## IN THE DRAWINGS

## Replacement Sheet

FIG.2

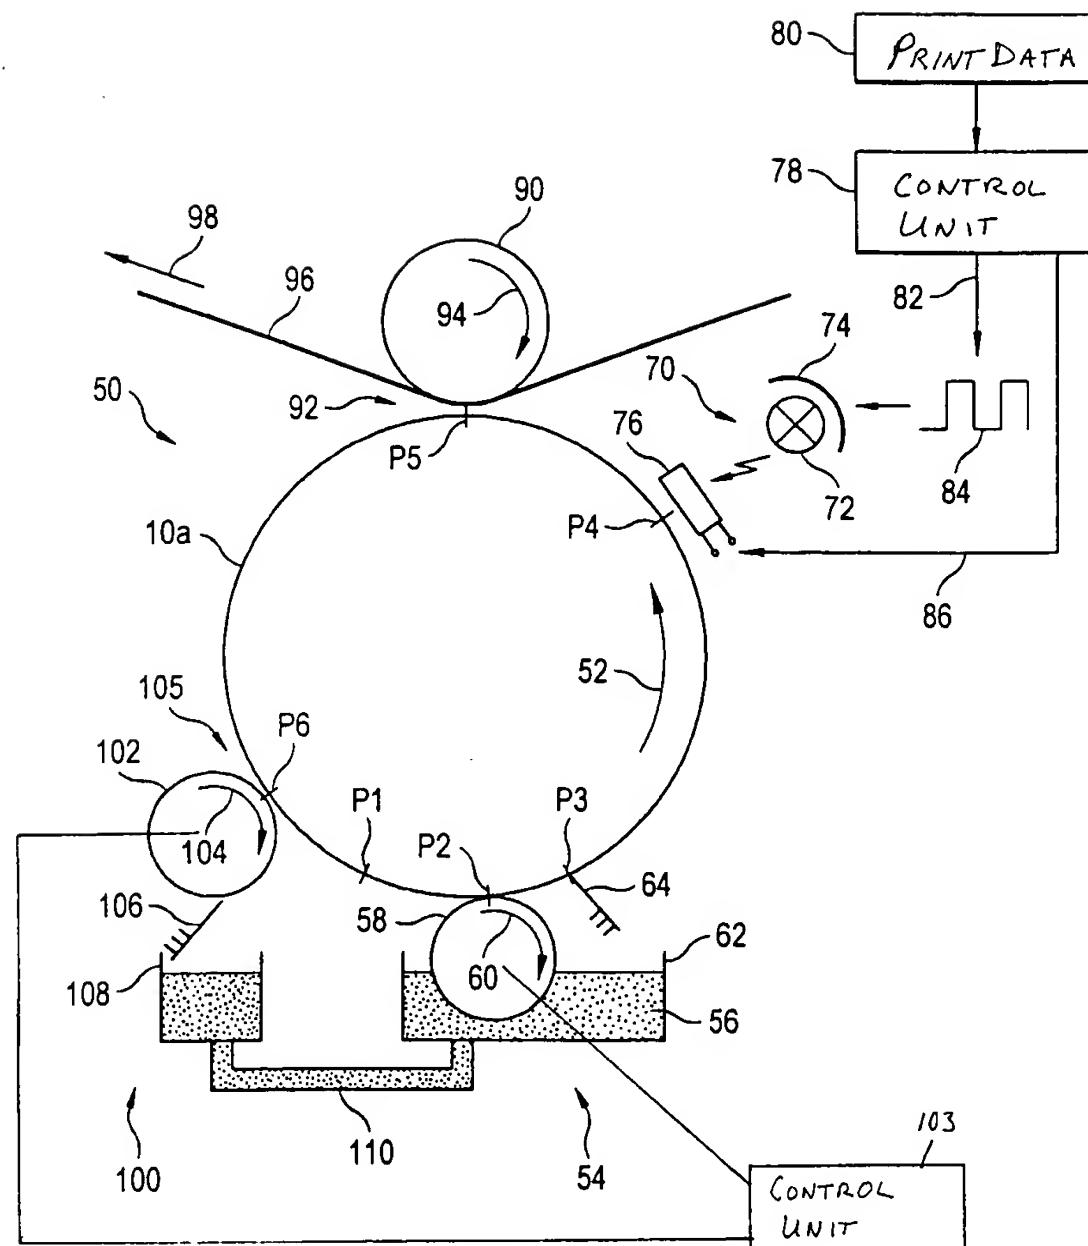
The drawing Figure 2 has been amended to add a control unit 103 for supplying power to the cleaning station and the inking station at the same time. The specification as filed disclosed that the cleaning station and the inking station operate simultaneously during the printing event (see page 3, lines 2 – 3, of the specification). Such simultaneous operation may be accomplished by applying power to both stations simultaneously, as would readily be understood from someone reading the specification. The claim 34 disclosed that this is accomplished by a control unit. This control unit is shown in the amended drawing, so that the claims are supported by the drawings. No new matter is added by this change.

The specification has been amended to identify the control unit 103.

Enclosed is an amended Figure 2 marked “Replacement Sheet”. Also enclosed is a copy of the Figure 2 marked to show the changes, which is marked “Annotated Sheet Showing Changes”.
